Enclosed is a design concept of the twin path
light table prepared by  incorporat-
ing your suggestions and comments. As is
apparent, to accomodate the large 1,000'
reels, he has made some rather drastic modi-
fications. We would appreciate your review
and comments. Also enclosed are comments
by John.

WORK STATEMENT

Your letter of 29 October received, preceded by the lists of objections. Your criticisms and suggestions are appreciated. We were disappointed to a degree but have given a lot of thought to ways of functionally meeting the objections.

**MICROSCOPE ADJUST
SCHEME #1 (PER W.G.M.)**

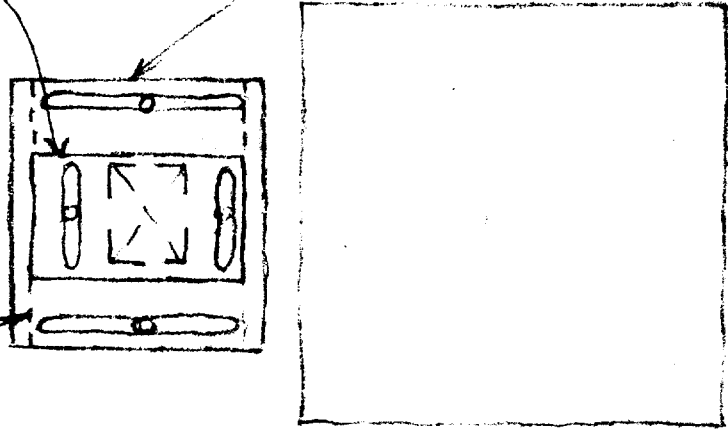
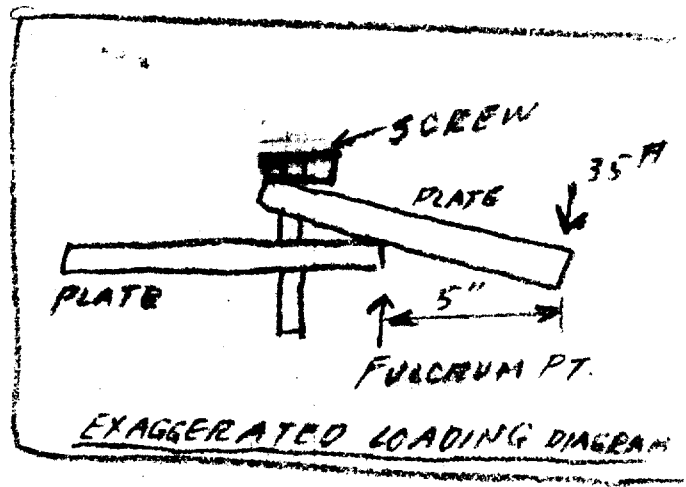
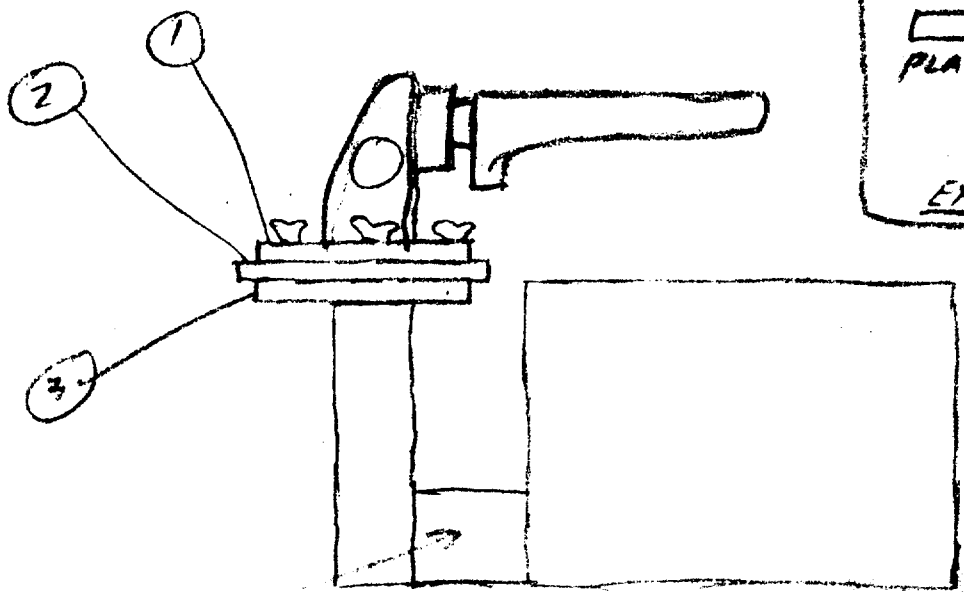
Enclosed are three sketches. Number 1 shows your suggestion carried as far as your notes indicate. I believe that the cantilever action on the plates when the microscope is extended would entail considerable binding and require an extra hand to hold up the microscope while tightening the screws. The microscope at seven pounds (including ring) exerts a 35-pound force when extended five inches, which is considerable on two screws and bearing load washers as you can see from the sketch diagram.

MICROSCOPE ADJUST SCHEME #2 (J.M.)

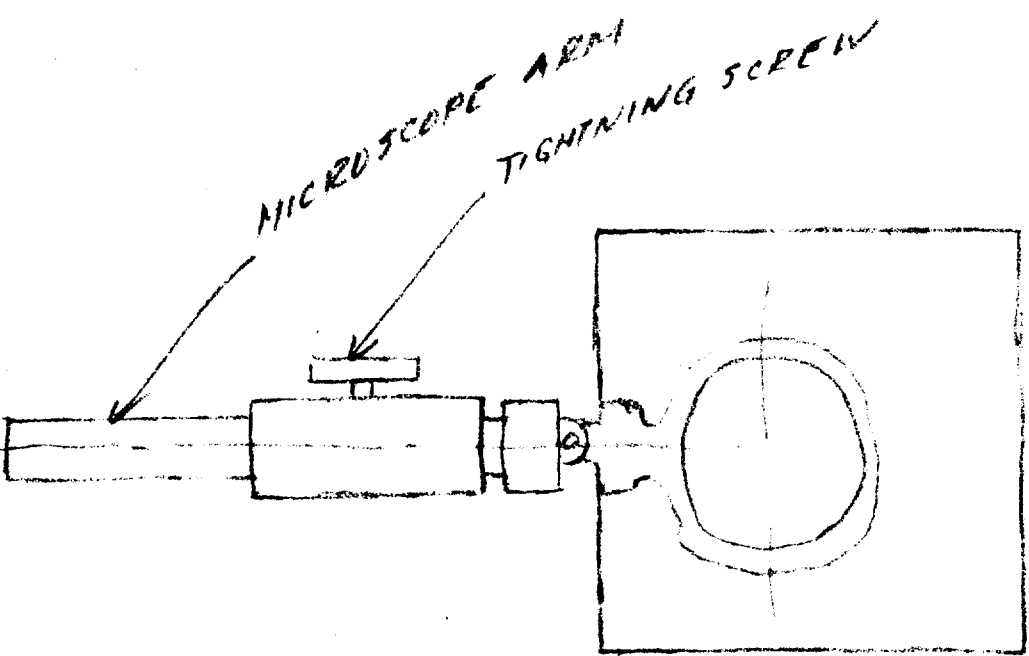
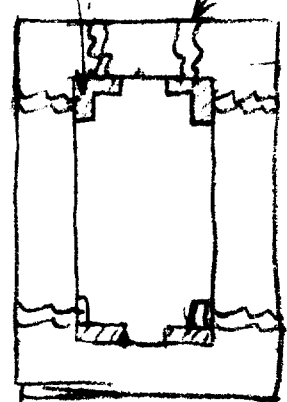
Sketch number 2 suggests a more rigid scheme but does not provide for lateral motion (not requested in original Work Statement).

DATE: 11-17-63 SUBJECT: LIGHT TABLE
TILT MECHANISM

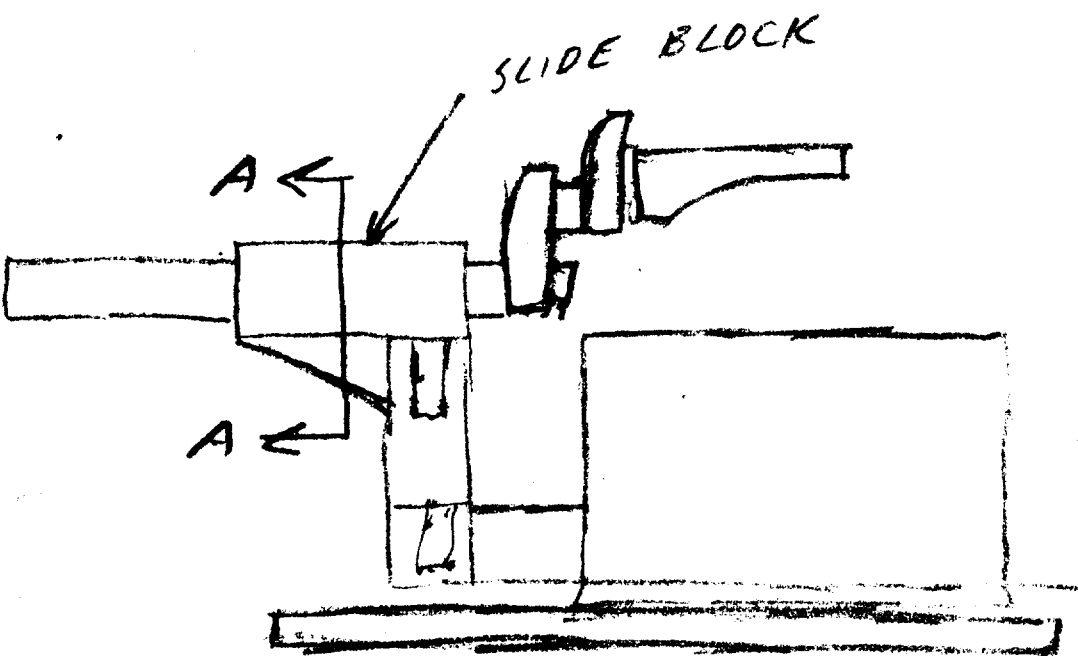
Sketch number 3 suggests a tilt mechanism scheme which we arrived at prior to receiving your letter. You will note that the second member provides a fulcrum for the prime moving link, thus reducing the screw load.
